# Proposed Comment Resolution for the MR-O-QPSK PHY

# IEEE P802.15

Title: Proposed Comment Resolution for the MR-O-QPSK PHY  
Date Submitted: January 20, 2011  
Source: Michael Schmidt - Atmel (email: michael.schmidt@atmel.com)  
Re: Task Group 15.4g LB59 comment resolution  
Abstract: Proposed comment resolution for the MR-O-QPSK PHY  
Notice: This document has been prepared to assist the IEEE P802.15. It is offered as a basis for discussion and is not binding on the contributing individual(s) or organization(s). The material in this document is subject to change in form and content after further study. The contributor(s) reserve(s) the right to add, amend or withdraw material contained herein.  
Release: The contributor acknowledges and accepts that this contribution becomes the property of IEEE and may be made publicly available by P802.15.

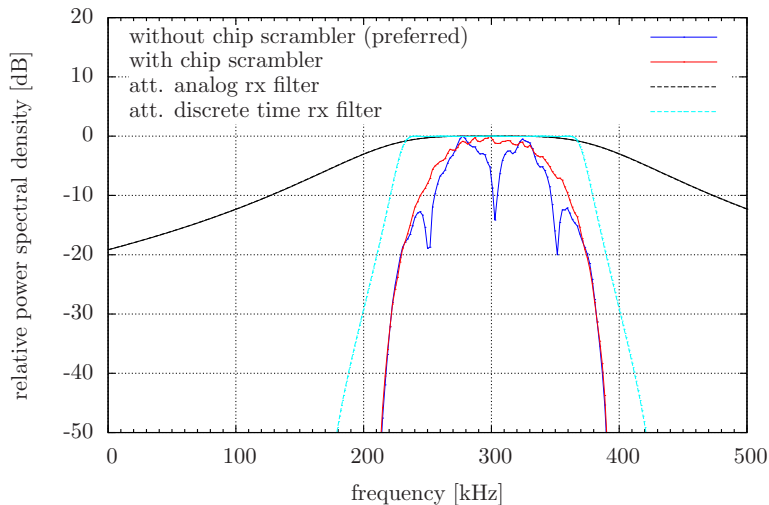
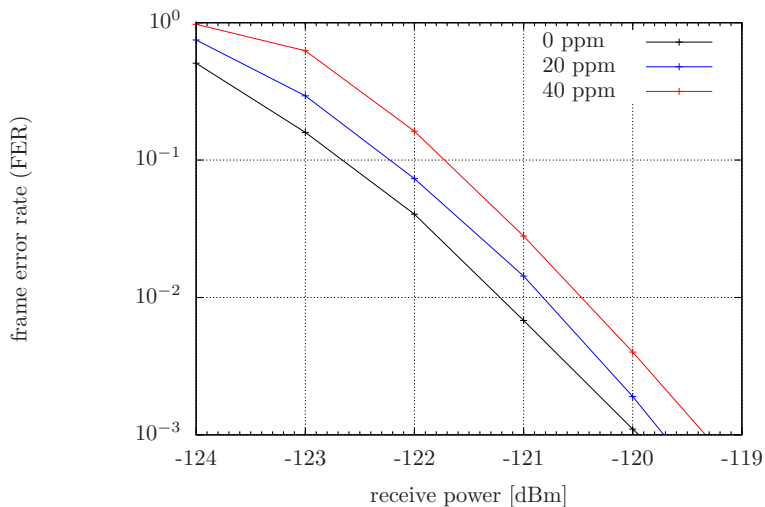
- ▶ Lower data rate should be considered in 470-510 MHz band for improved link budget.
- ▶ Add new data rate of 6.25 kbps with (8,1)-DSSS and rate 1/2 FEC.

IF:	300 kHz
analog receive filter:	2-nd order $f_{cut} = 100$ kHz
analog high pass filter:	2-nd order $f_{cut} = 50$ kHz
ADC:	6 bit at 4 MHz
discrete time receive filter:	FIR + 5-th order IIR ( $f_{cut} = 62.5$ kHz)
LNA noise:	-174 dBm/Hz + 5 dB noise figure

- ▶ true timing sync
- ▶ true frequency offset estimation

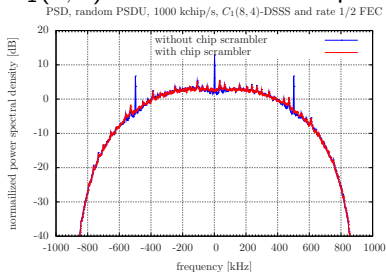
- ▶ Cross correlation of (8,4)-DSSS code is poor
- ▶ Non-coherent detection is not possible
- ▶ Consider (8,4)-DSSS code given in 15-10-0281-04-004g

- ▶  $C_0(8,4)$  is an extended BCH code.
- ▶ The distance properties of the inner block code are less relevant (due to outer rate 1/2 FEC).
- ▶ However, the coding gain of  $C_0(8,4)$  can be exploited for a decision feedback based phase control loop<sup>3</sup>.
